Well Name: CYPRESS 33 FED COM	Well Location: T23S / R29E / SEC 28 / SESE / 32.2687261 / -103.9843421	County or Parish/State: EDDY / NM
Well Number: 214H	Type of Well: CONVENTIONAL GAS WELL	Allottee or Tribe Name:
Lease Number: NMNM086024, NMNM136211	Unit or CA Name:	Unit or CA Number:
US Well Number: 3001547845	Well Status: Approved Application for Permit to Drill	Operator: TAP ROCK OPERATING LLC

Notice of Intent

Sundry ID: 2643946

Procedure Description: Tap Rock requests to change the BHL for the referenced well to: 30' FSL - 895' FEL, Lot P Section 33, T23S-R29E See attached updated plat.

WELL LOCATION AND ACREAGE DEDICATION PLAT

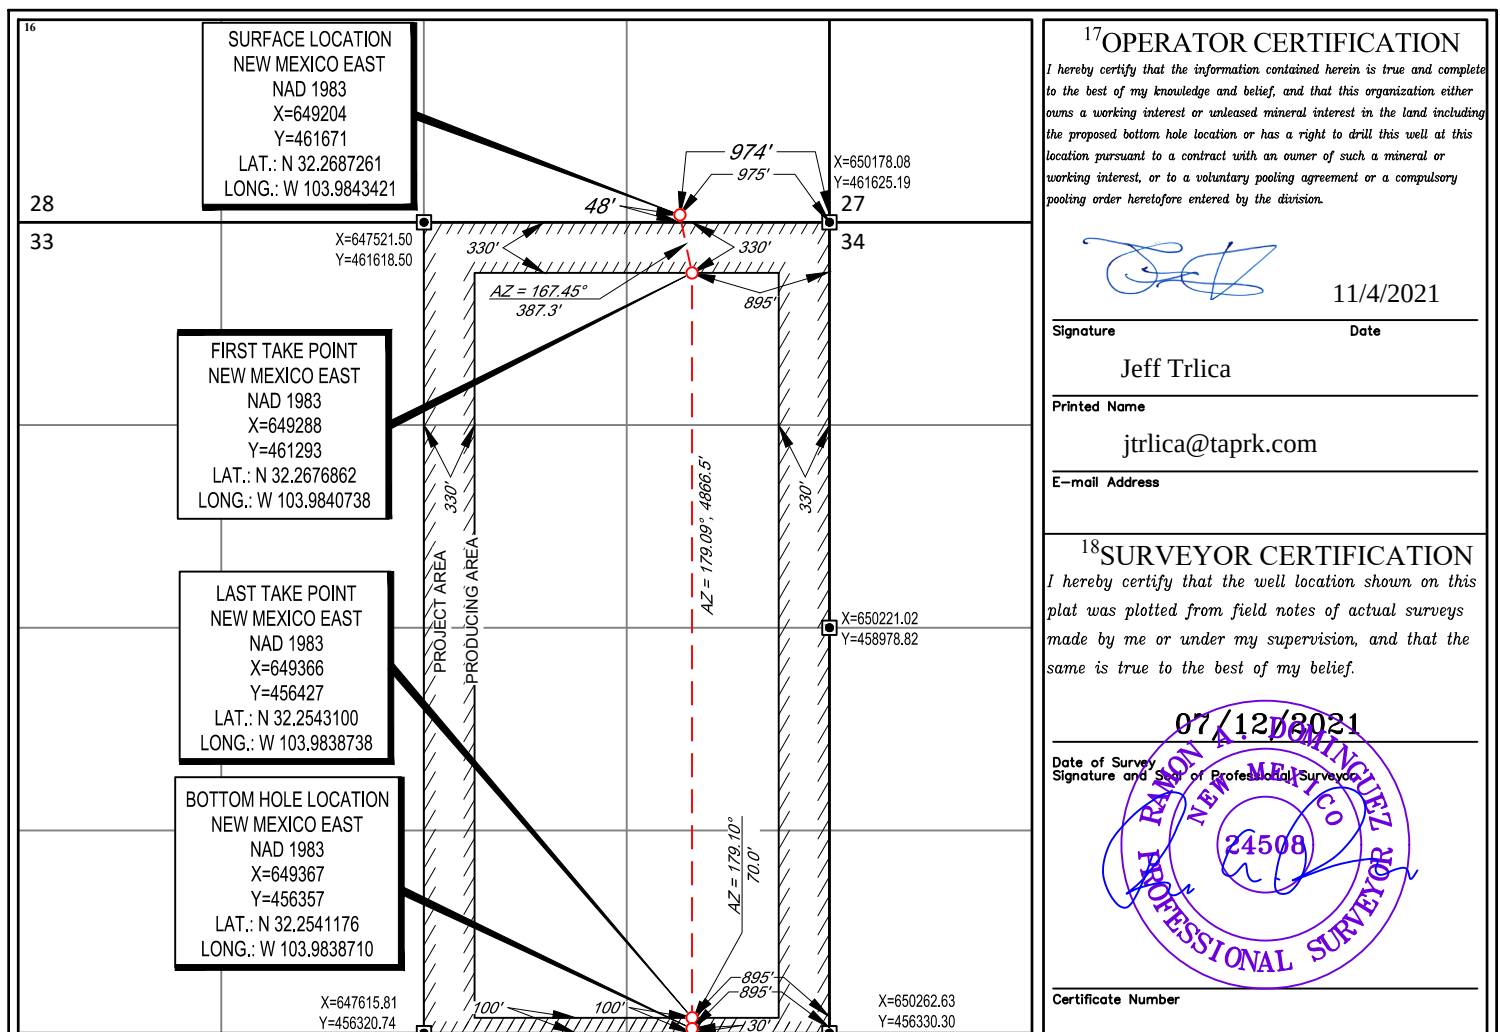
UL or lot no.	Section	Township	Range	Lot Idn	Feet from the	North/South line	Feet from the	East/West line	County
P	33	23-S	29-E	-	30'	SOUTH	895'	EAST	EDDY

Created By	Condition	Condition Date
kpickford	NSL Will require an administrative order for non-standard location prior to placing the well on production	11/23/2021
kpickford	Adhere to previous NMOCD Conditions of Approval	11/23/2021
